Docket Item #7
BAR CASE #2010-0321

BAR Meeting
December 1, 2010

ISSUE: Signage, Canopy and Lighting
APPLICANT: Circe Salon by Maginnis/DelNinno Architects
LOCATION: 123 North Washington Street
ZONE: CD / Commercial

Figure 2. Existing Spot lights to be Removed

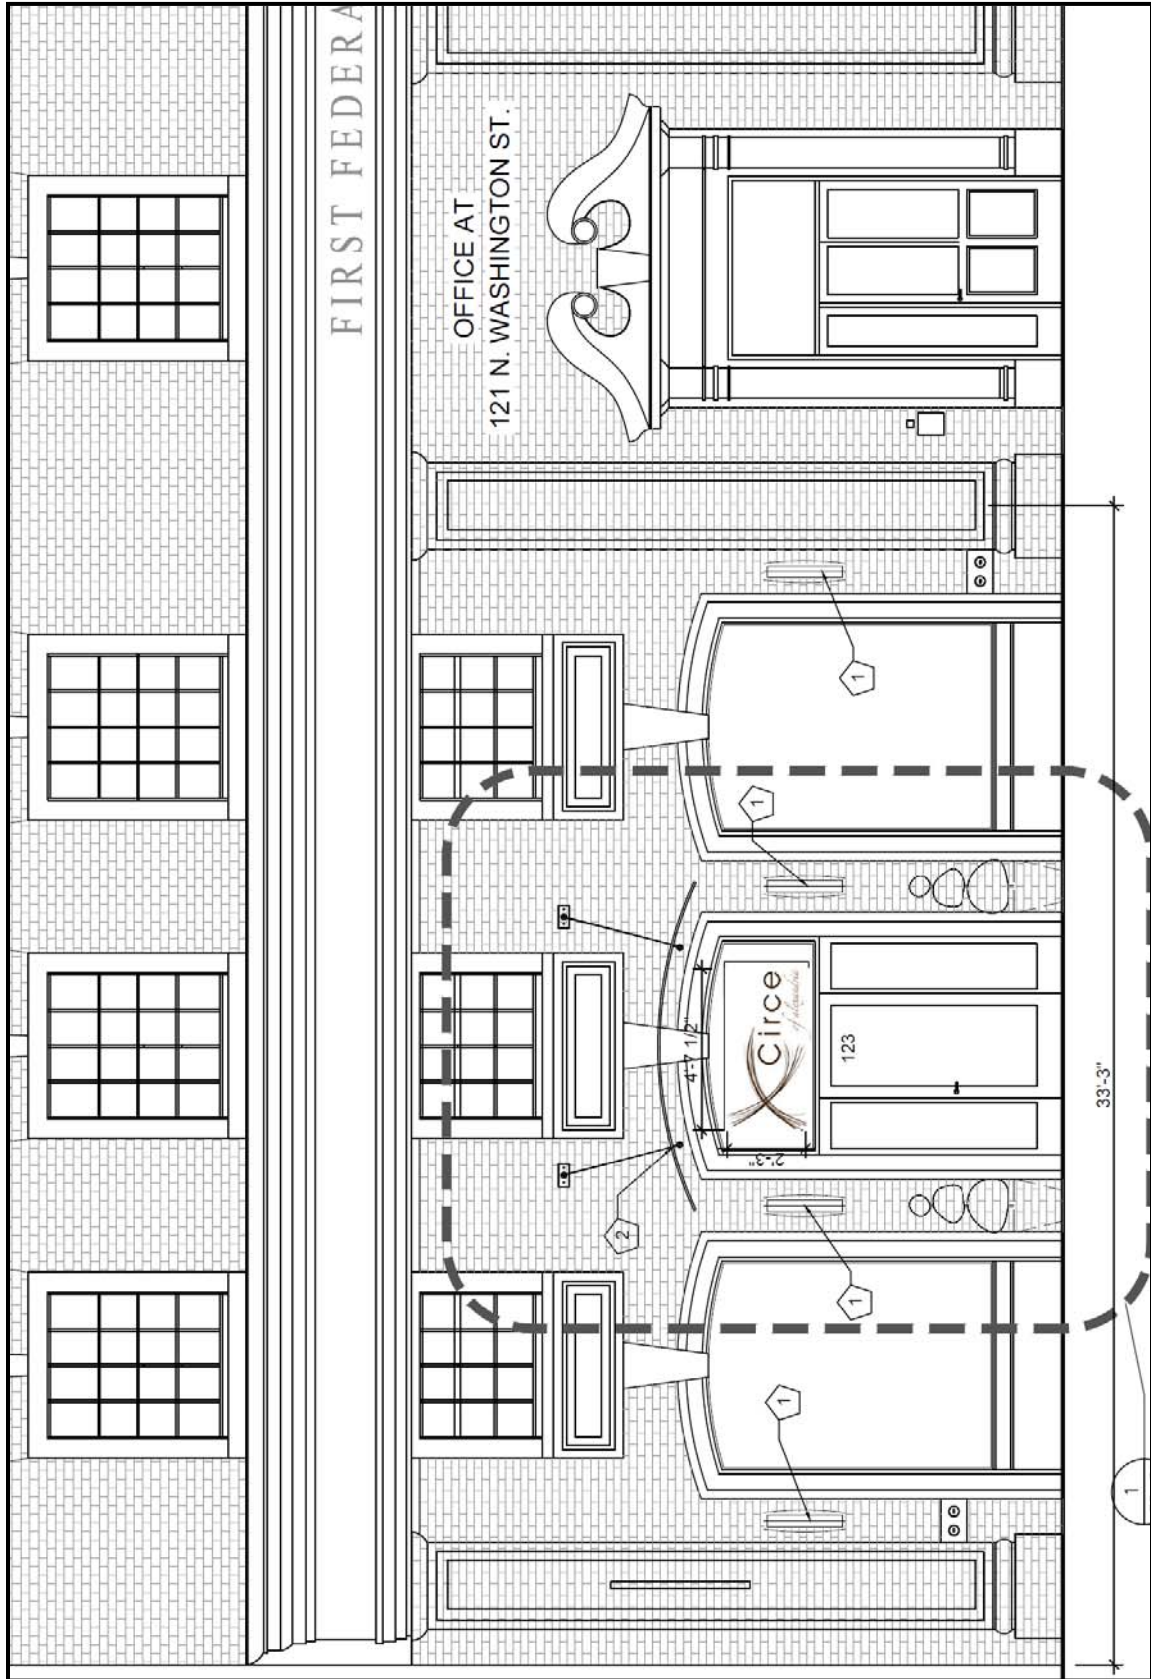
The applicants are also proposing to remove four existing spot lights from the building and replace them with four sconces which flank the door and windows on the storefront. The oval shaped, sconces are modern in design, yet simple in form. They will not detract from the architectural character of the building. Additionally, their placement will not hide or require the removal of historic architectural features, as recommended in the *Guidelines*.

Figure 3: Proposed Alterations to Front Elevation

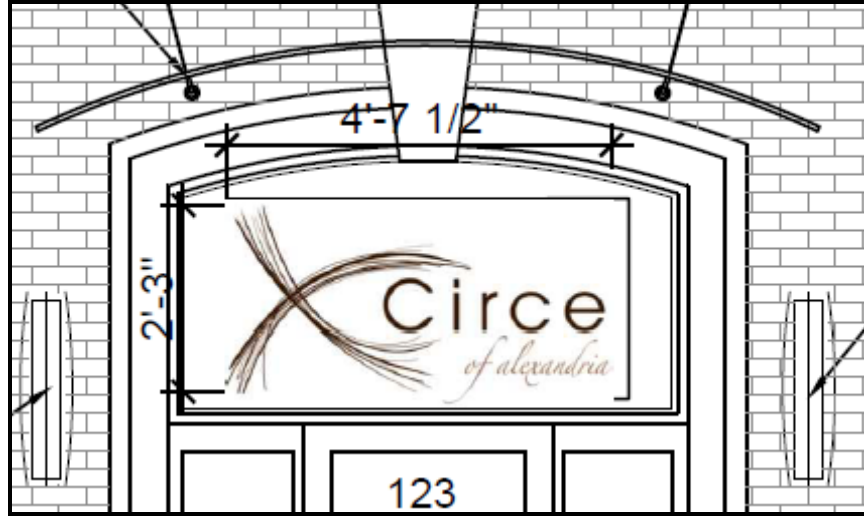
Staff believes that the design for the canopy is an excellent example of how to implement a new design element onto a historic building without destroying its architectural integrity, damaging historic fabric or negatively impacting the streetscape. The design of the canopy is clearly modern but does not detract from the mid-20th century style of the building, which is elegant in design and ornamentation. However, the new canopy will be clearly differentiated from the

original building. Finally, the canopy, as designed, will not obscure any of the building's architectural detailing and is being installed so it can be easily reversible.

Figure 3. Proposed Decal Sign in Transom

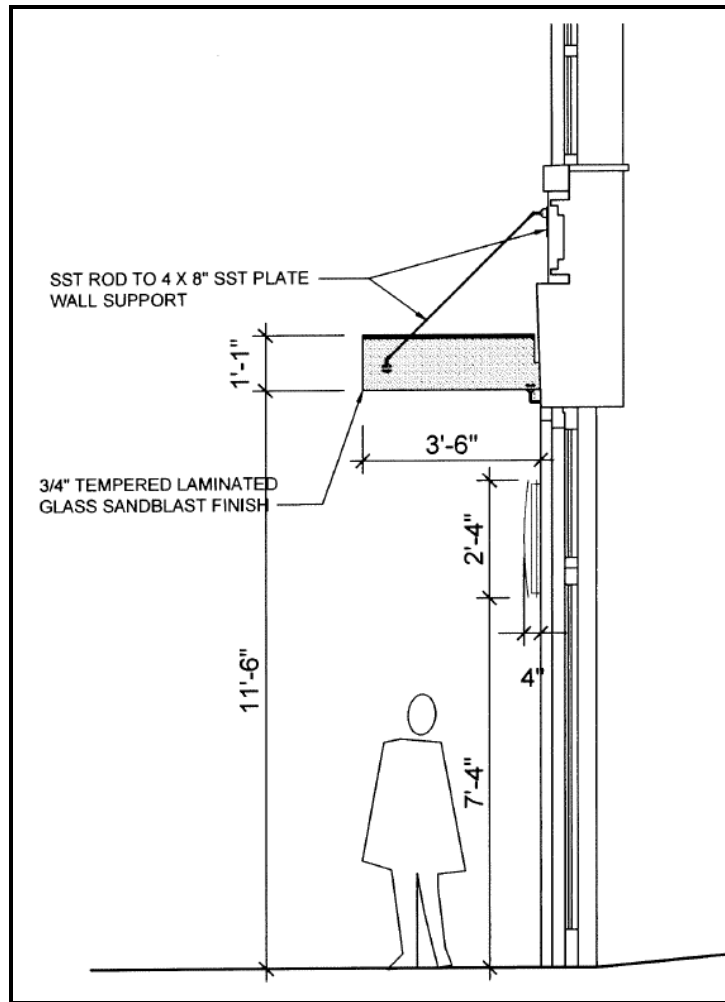
According to the *Design Guidelines*, "Signs should be designed in styles, materials, type faces, colors and lettering that are appropriate and sympathetic to the historic style of the building." The applicant is proposing to reduce their existing signage by eliminating the existing banners, and window signage and return to more traditional window decal above the entry. Staff supports this return to a more modest level of signage.
